FDOT District 1 Comments
FP&L Post Certification Submittal for Segment 3 of the FPL Sweatt – Whidden Line

SWEATT - WHIDDEN 230KV LINE
FDOT PARALLELISM EXHIBIT
COVER SHEET

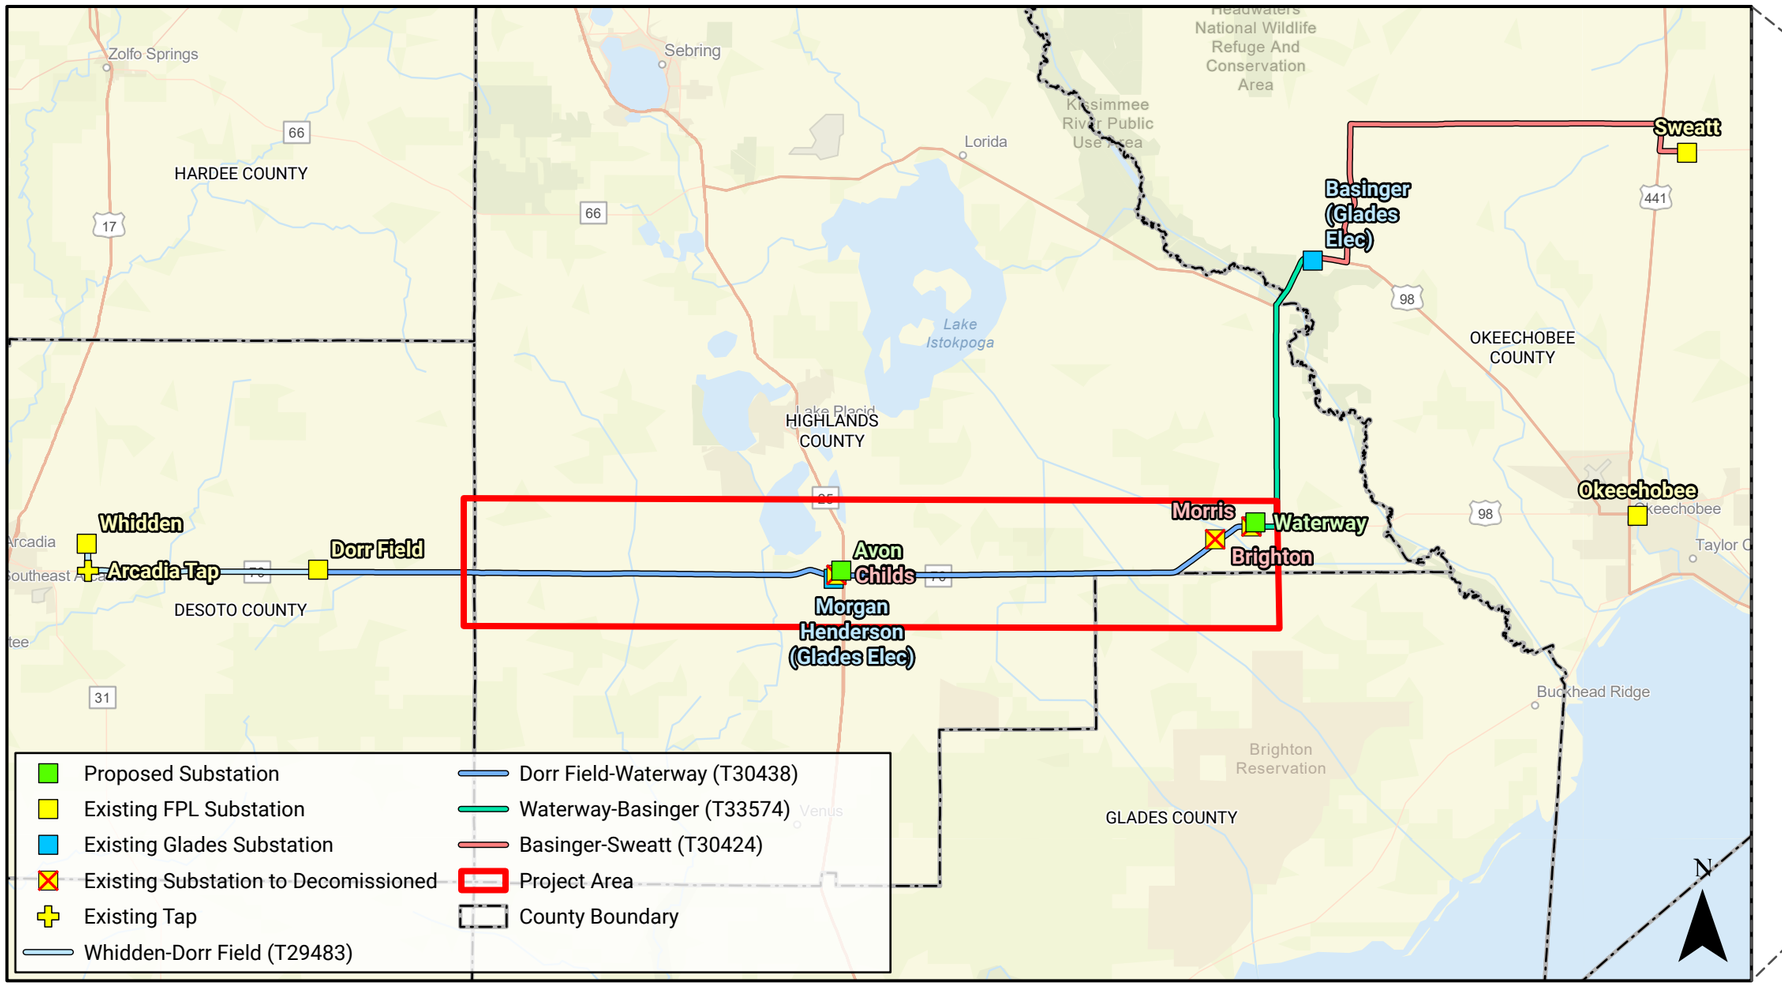
8. The cover sheet of the Waterway-Dorr Field Parallelism Exhibit, located on pg. 33 of the package, references the 2023-24 FDOT Standard Specifications. Should this be 2024-25?

FPL response: The FDOT Standard Specifications version has been updated to 2024-25.

STR 31L5 THROUGH 32L5
STR 32L11 THROUGH 32L16
STR 33L8 THROUGH 33L13

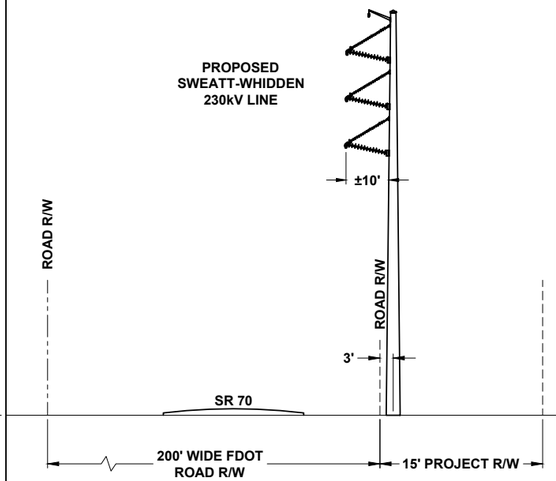
9. Poles 31L5, 31L7, and 31L9 are all located adjacent to existing poles, but several feet away from the SR 70 R/W line. In general, it would be good if the poles were at a standard location, relative to the northern SR 70 R/W line.

11. Can Pole 32L11 be shifted to the north to avoid potential future roadway conflicts?

FPL response: Based on FPL's review of the affected easements associated with the structures listed above, an adjustment to the centerline location of FPL's facilities within the easement would not only require the acquisition of additional easement rights on adjoining properties and is also inconsistent with the intent of the original easement language.

FPL response: Based on FPL's review of the affected easements associated with the structures listed above, an adjustment to the centerline location of

FPL's facilities within the easement would not only require the acquisition of additional easement rights on the adjoining property and is also inconsistent with the intent of the original easement language.

STR 32L7 THROUGH 32L9
STR 33L1A THROUGH 33L7

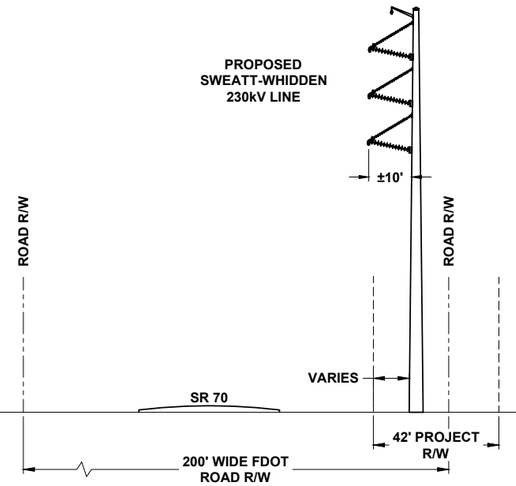
10. Pole 32L9 is located outside of the Project ROW. Why are proposed features located outside of the Project ROW?

FPL response: This was a graphical error in how the Project ROW was drawn. The dimensions on the original drawing were correct. The linework of the Project ROW has been corrected to match this and proposed transmission features are all located within Project ROW.

US HWY 27 CROSSING
PROPOSED SWEATT-WHIDDEN 230kV TRANSMISSION LINE
SEGMENT: WATERWAY-AVON
PROFILE VIEW
LOOKING NORTH

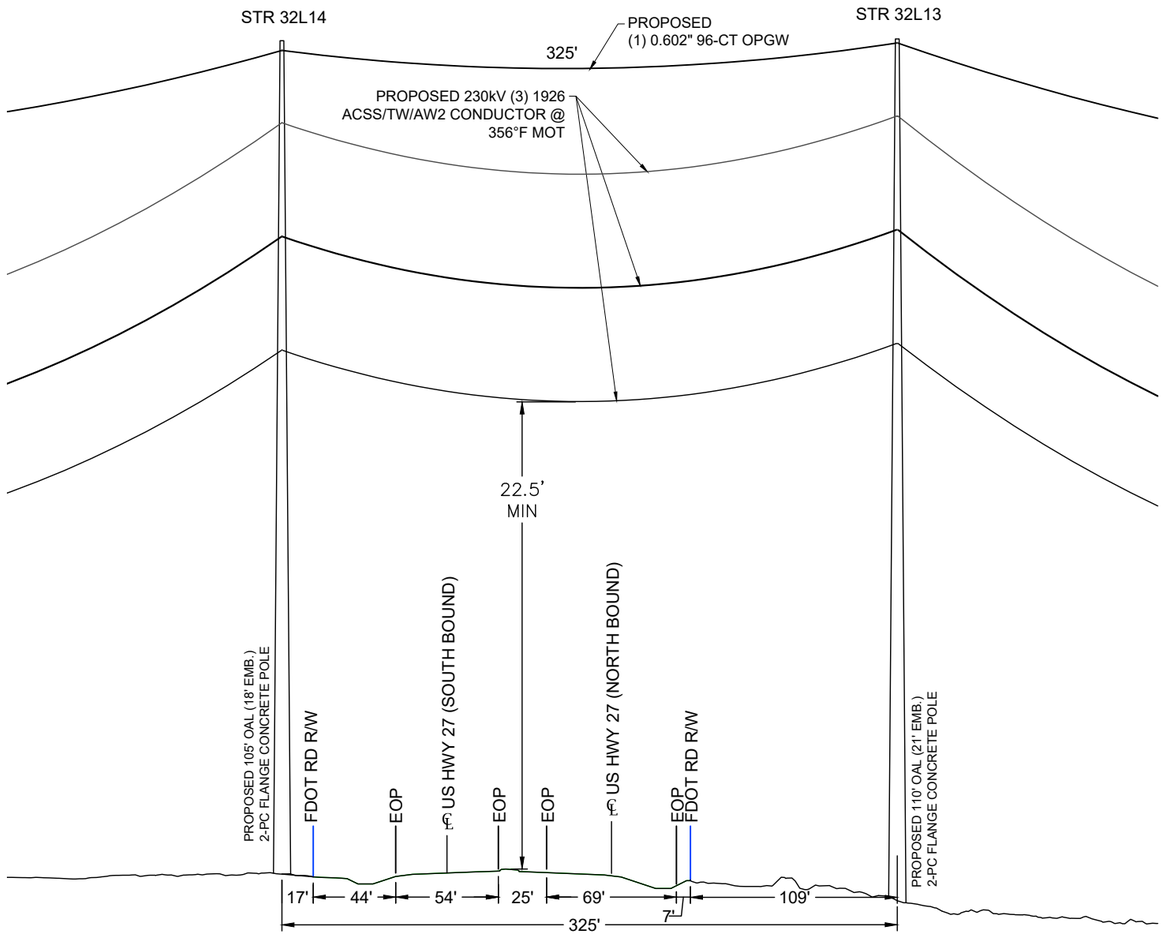
4. There is a profile view of the transmission lines (US 27 cross section) crossing of US 27 on pg. 11 of the package. The roadway cross section at this location looks extremely bumpy. Does this take into account the final proposed pavement elevation of US 27 from the concrete pavement project that recently finished construction?

FPL response: FDOT provided as-built drawings of the groundline at the point of crossing. The elevations from the as-built were also confirmed against a recent ground survey recently performed. The revised profile drawings now includes the latest elevations as part of the ground profile.
